TO: All Bidders
FROM: City of Cambridge
DATE: January 24, 2014
RE: File No. 5849C –Dr. Martin Luther King Jr. School Construction
Project- Addendum NO. 5

Addendum No. 5

Project: Dr. Martin Luther King Jr. School Construction Project

Regarding: Bid Addendum 5 – Volume 1

PROJECT: Martin Luther King, Jr. School Construction Project
DRAWING TITLE: REVISED OCS 101 DETAIL, SHEET C901
DATE: 01.24.2014 ADDENDUM 5

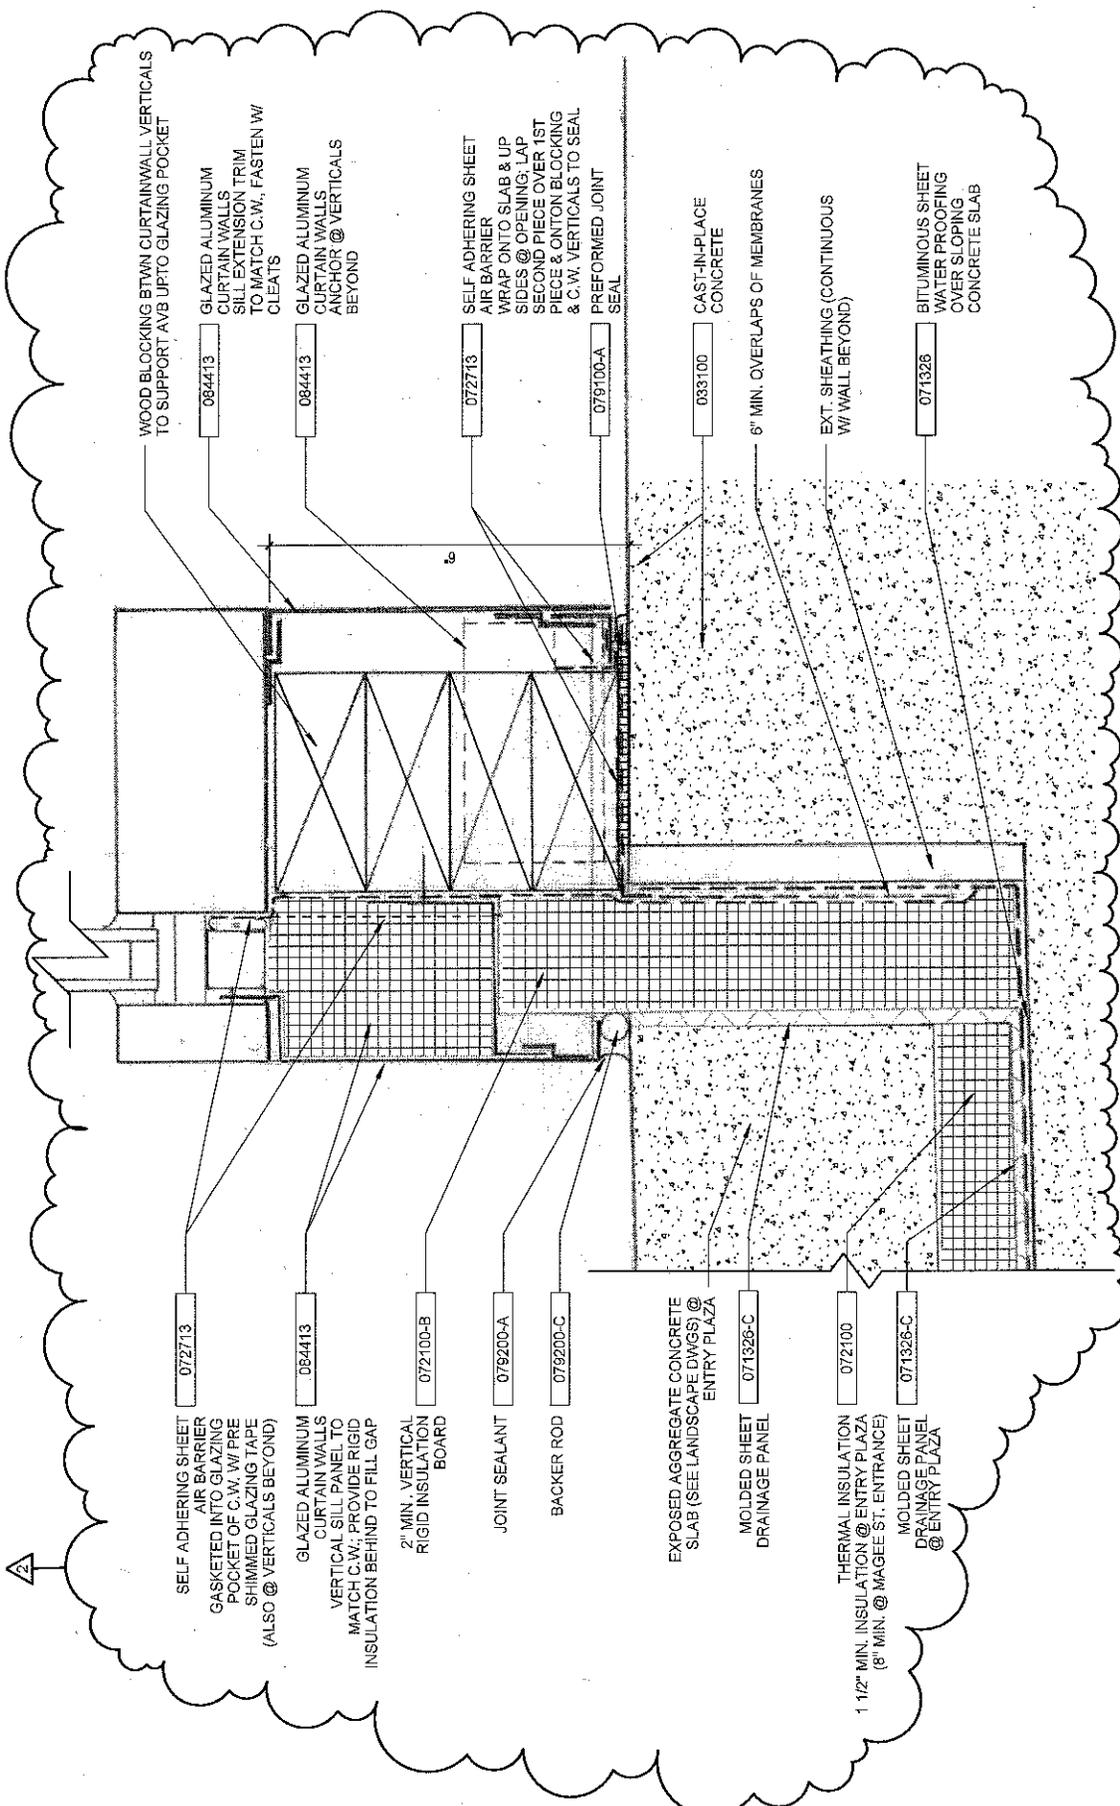
21	Specification	Subject:	Cubicle curtain mockup
		References:	Specification 102123 Cubicles
		Description:	Delete Paragraph 1.5 in its entirety.
#	DISCIPLINE	ISSUE	DRAWINGS
01	Civil	Subject:	Outlet Control Structures
		References:	Sheet C301 / SKC-005
		Description:	Modified steel plate orifice diameters for outlet control
02	Civil	Subject:	Roof Drain Discharge Line at Loading Dock
		References:	Sheet C100 / SKC-006
		Description:	Modified pipe size to 18" CPP and invert into DMH106 and outlet invert of plumbing connection at building.
03	Architecture	Subject:	Clarification of "King Street" Nomenclature
		References:	Drawing Set
		Description:	"King Street" refers to the Vestibules & Corridor spine between grid lines neA.1 and neB @ all roofs of the building.
04	Architecture	Subject:	Roof Plan Clarifications
		References:	A104
		Description:	<p>Refer to reissued A104 which includes to following clarifications:</p> <ul style="list-style-type: none"> • Turned off PV layer allow for clarity of roof information (PV's shown on electrical drawings) • Added wall section keys. • Added note to Roof Type R1, "Default roof type unless noted otherwise."

PROJECT NO. 47931.00
SCALE: 8" = 1'-0"
SHEET: 2/A&17
REFERENCE:
DWG. NO.: SKA-001

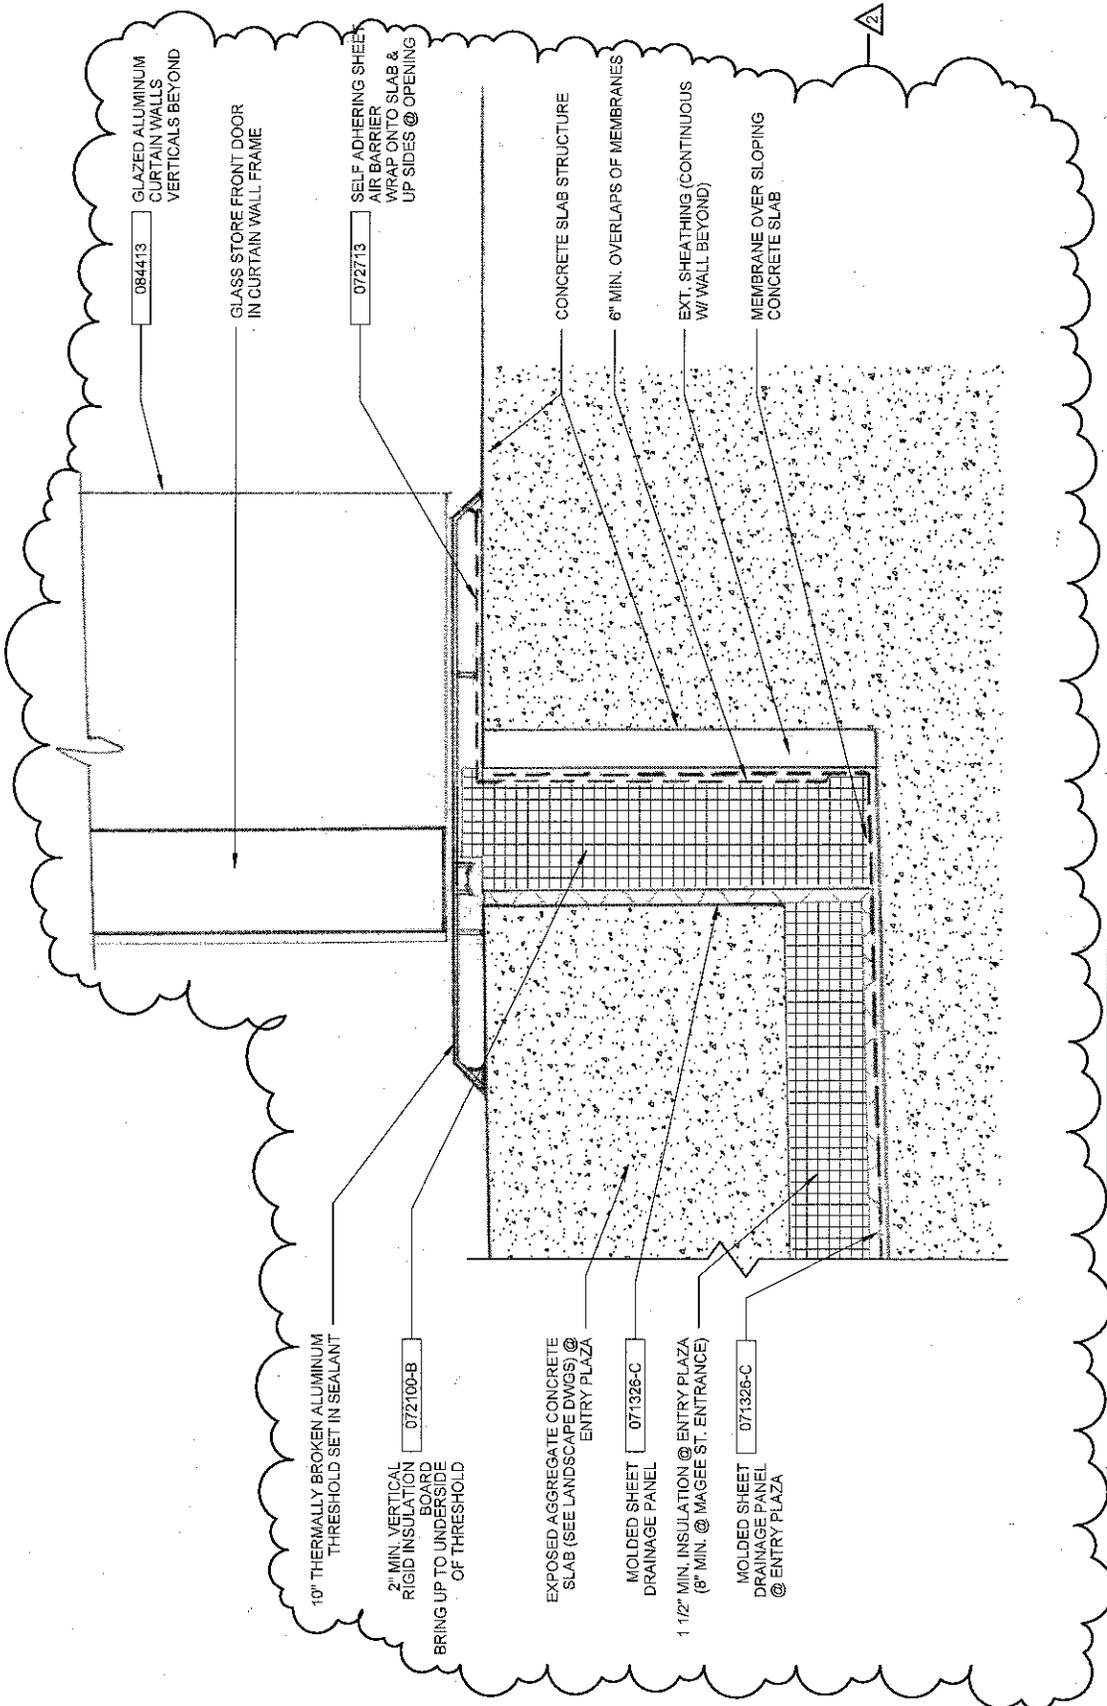
Revised R: Refer to attached reissued A614.
25	Architecture	18_Chapman_03_#4	Q: Will joint sealant by specification section 079200 occur at the interior perimeter of frames to drywall at any locations at the curtain wall frames indicated on drawing A614? R Addendum 4: See Sheet A614 reissued in Addendum 4.
			Revised R Addendum 5: Yes. Refer to attached reissued A614 and SKA-001 through SKA-007.
26	Architecture	18_Chapman_03_#5	Q: Will one bead of joint sealant by specification section 079200 occur at the interior and exterior perimeter of all frames indicated on drawings A513 whether detailed or not? R Addendum 4: See Sheet A513 reissued in Addendum 5.
			Revised R Addendum 5: Refer to Typical Window details SKA-008, SKA-009 & SKA-010 for joint sealants.

PROJECT NO. 47931.00
 SCALE: 1/4" = 1'-0"
 SHEET A610
 REFERENCE
 DWG. NO.: SKA-014

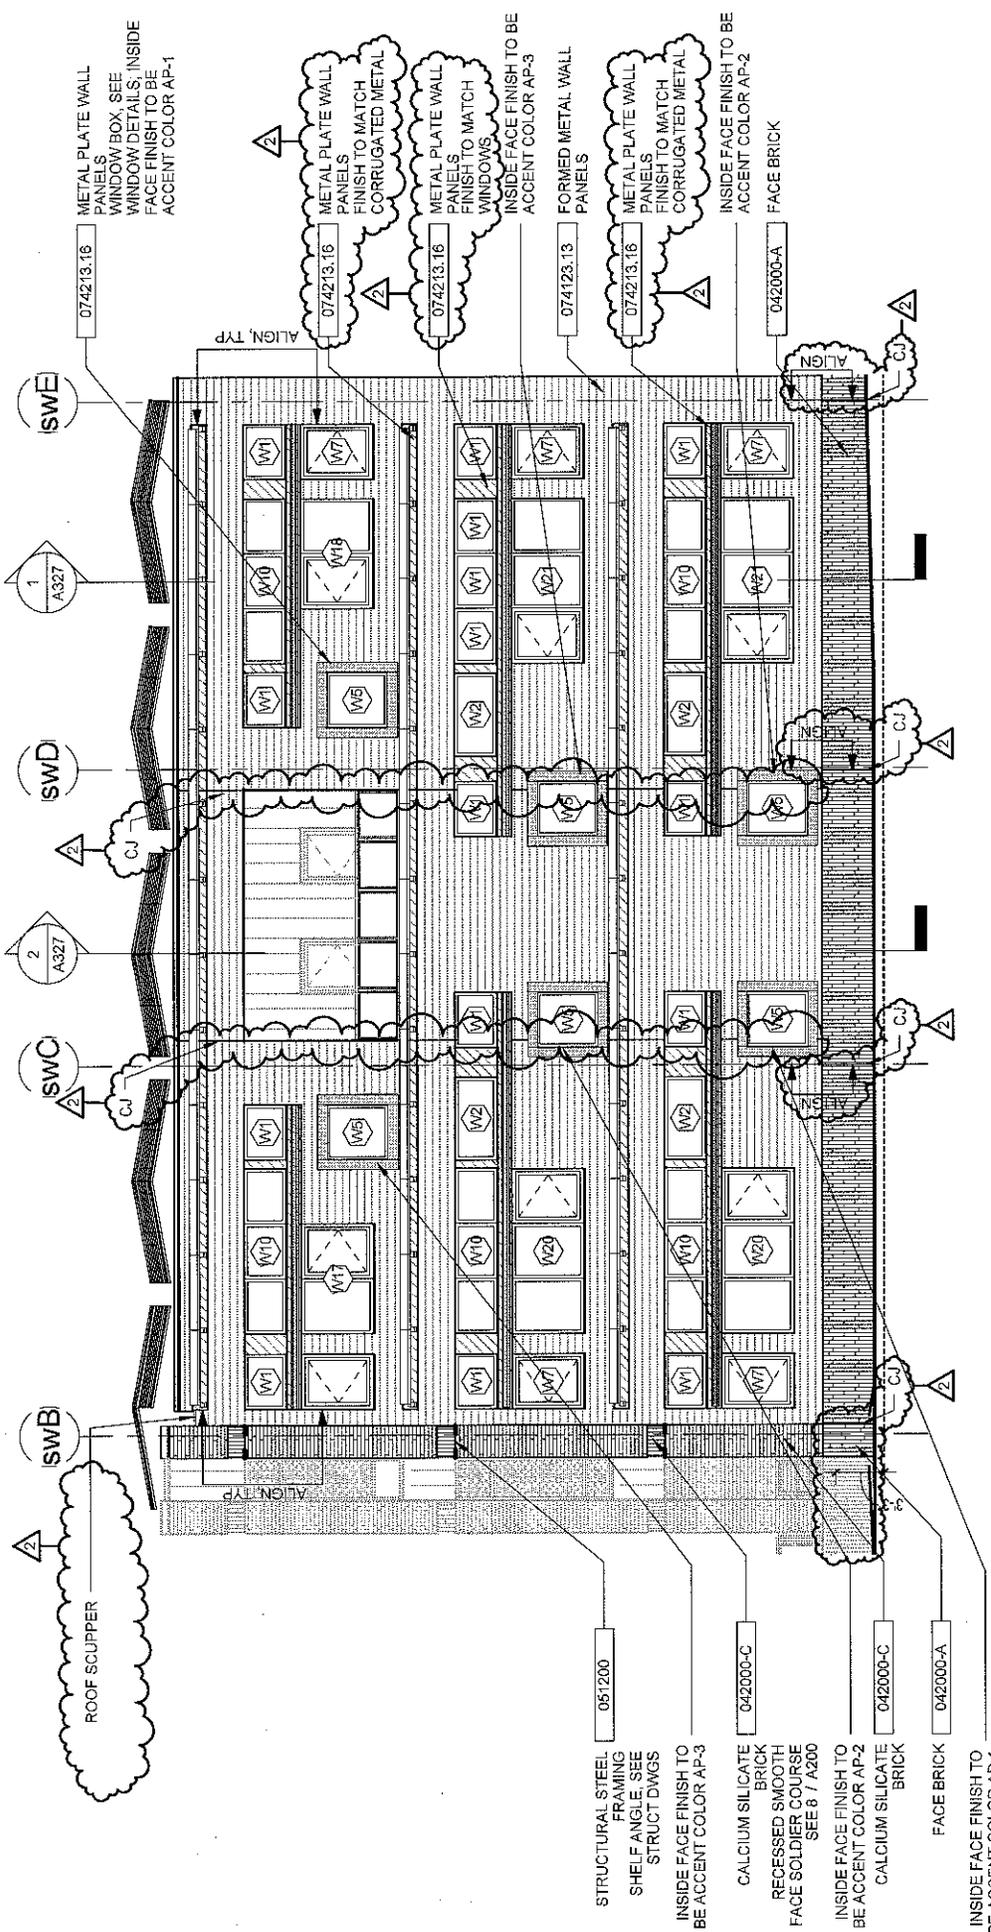
ADDENDUM 5 FSB QUESTIONS			
01	Architecture	100_NHSF_03	Q: The attached are the only sheets I have for Section 011300 CM PROJECT SCHEDULE. I NEED PAGES 1-4 PLEASE. This is very important for it advises milestone dates for materials to b on the site. R: All of the pages have been provided in the original document and supplemented by Addendum 2 (for pages 9 and 10).
02	Architecture	103_NHSF_04_#1	Q: Aluminum outriggers. They are now listed in specification 055000 Metal Fabrication but when looking at the drawings A513 it is still shown by the structural steel fabricator. R: Follow Structural drawings for delineation of scope of work. Everything outside the WT “bracket, as indicated on the attached reissued A513 is to be by 055000 Misc Metal.
03	Architecture	103_NHSF_04_#2	Q: Stainless Steel base cladding also no listed in our spec 055000 Metal Fabrications. Per drawing IN001 this is provided by 64023. Please take this out of section 055000 Metal Fabrications for this is an item NEVER supplied by Metal Fabrications. R: Stainless steel base cladding in Detail 2/A8.05 furnished

and installed by 064023. Corrected in Addendum 5.
04	Architecture	103_NHSF_04_#3	<p>Q: We assume the addendum #4 drawings are a complete replacement of the Structural and Architectural drawings as advised in previous memos from WT Rich the Construction manager. Can you kindly confirm that I can roll up the old Architectural and Structural steel drawings and use these new ones as my Metal Fabrications Take Off Set. Please confirm.</p> <p>R: Yes. Refer to Addendum 4 - Summary Volumes 1 & 2.</p>
05	Architecture	104_NHSF_05_#4	<p>Q: I have received addendums #1 and #2 via email and I have picked up Addendum #2 but I have no addendum #3. Please advise.</p> <p>R: Per Summary Volumes 1 & 2, Addendum 3 drawings are included in Addendum 4. Also refer to City of Cambridge Purchasing Department Addendum No 3 memo to all bidders dated December 23, 2013. "The structural drawings including concrete and structural steel, have been issued to the Construction manager at Risk. These drawings shall be included in the January 13, 2014 bid package for the trade bidders.</p>

Perkins Eastman		PROJECT: Dr. Martin Luther King, Jr. School		ADDENDUM #5
50 FRANKLIN STREET SUITE 203 BOSTON, MA 02110 T: 617.466.6000		PROJECT NO.: 47931-00	SCALE: 3" = 1'-0"	
		SHEET: 6/A510, 10/A510	REFERENCE:	
		DATE: 1/24/2014	DWG. NO.: SKA-018	
		DRAWING TITLE: PARAPET DETAILS

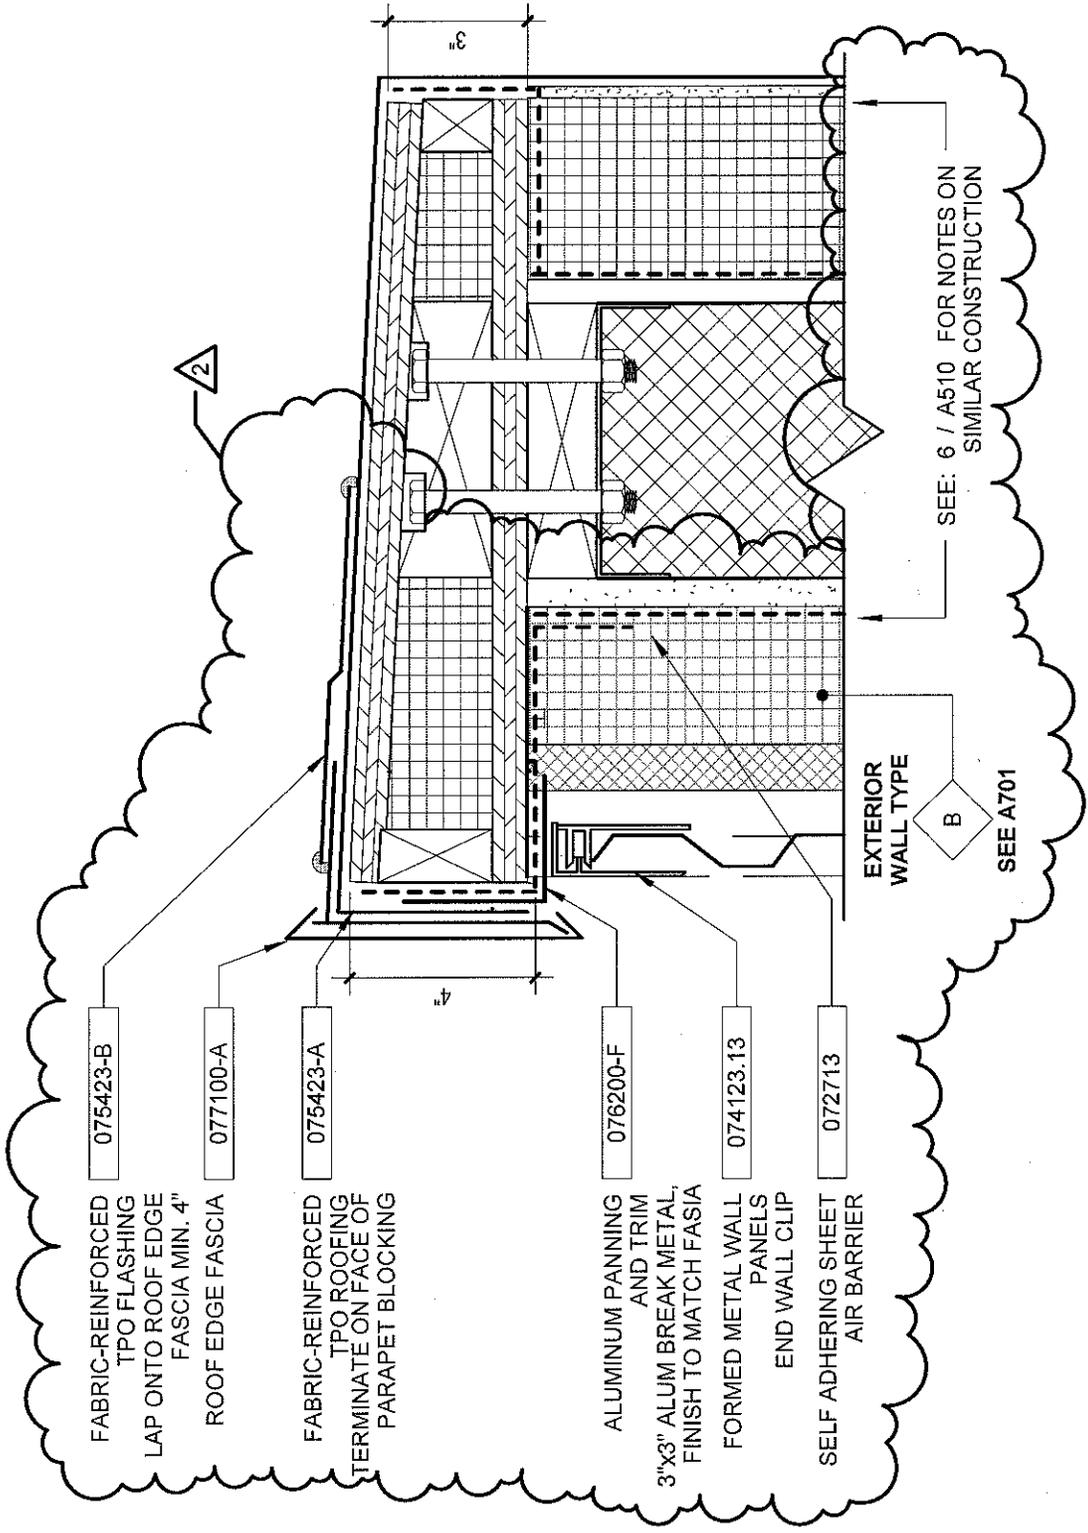
61	Architecture	Subject:	Parapet Details
		References:	6 & 10 / A510, SKA-018
		Description:	Clarified parapet details per attached sketch.
62	Architecture	Subject:	Detail Key Clarification
		References:	8 /A510
		Description:	Add "079100A" to "shim and compressed impregnated foam tape note?"
63	Architecture	Subject:	King Street Fiberglass Sandwich Panel
		References:	14/A511, SKA-017
		Description:	Clarified fiberglass sandwich panel per attached sketch.
64	Architecture	Subject:	Corrugated Metal – Parapet Enlarged
		References:	4/A511, SKA- 019
		Description:	Added parapet detail 14 per attached sketch.
65	Architecture	Subject:	Clarifications A513
		References:	A513
		Description:	Clarified details per attached reissued drawing.
66	Architecture	Subject:	Waterproofing at Lower School Areaway West
		References:	2/A514, SKA-020
		Description:	Clarified waterproofing at lower school areaway per attached sketch.

DRAWING TITLE: 0022A ENTRY - ELEVATIONS

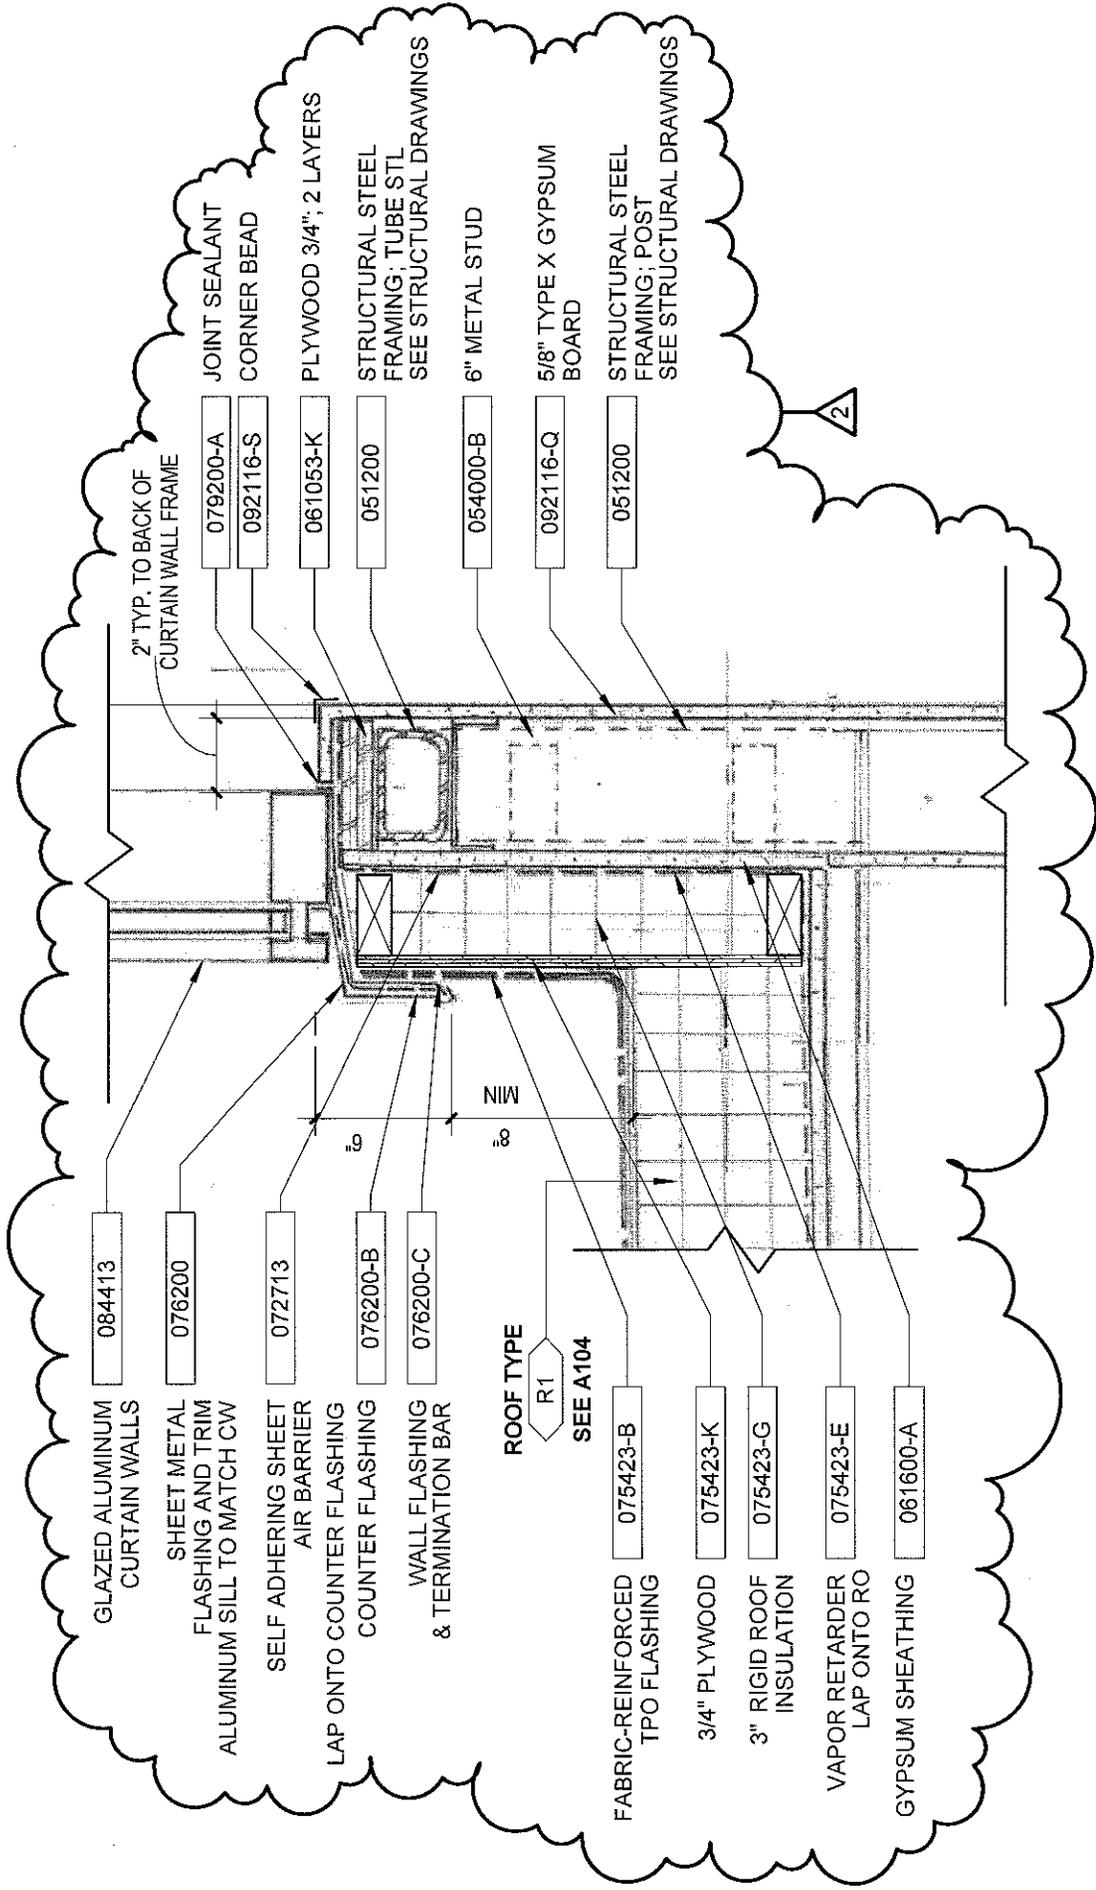
45	Architecture	Subject:	0022A Entry Elevations
		References:	3 & 4/A403, SKA-027
		Description:	Clarified elevations per attached sketch.
46	Architecture	Subject:	Wall Clarification
		References:	2/A403.1
		Description:	Add horizontal line to continue wall / beyond at area of exit sign.
47	Architecture	Subject:	Elevation Key Clarification
		References:	1 / Dining Servery Casework Key below Grid 6.9
		Description:	Add "A406.2" to elevation key.
48	Architecture	Subject:	Auditorium Clarifications
		References:	A408, A408.1, A408.2
		Description:	Attached drawings reissued to clarify interior walls and panels that were missing from previous plot issued in Addendum 4.
49	Architecture	Subject:	Wall Visibility Clarification
		References:	A409.2
		Description:	Delete wall graphic at grid line M between grids ne1 and 8; wall is not full height and should not appear on RCP.
50	Architecture	Subject:	Detail Key Clarification
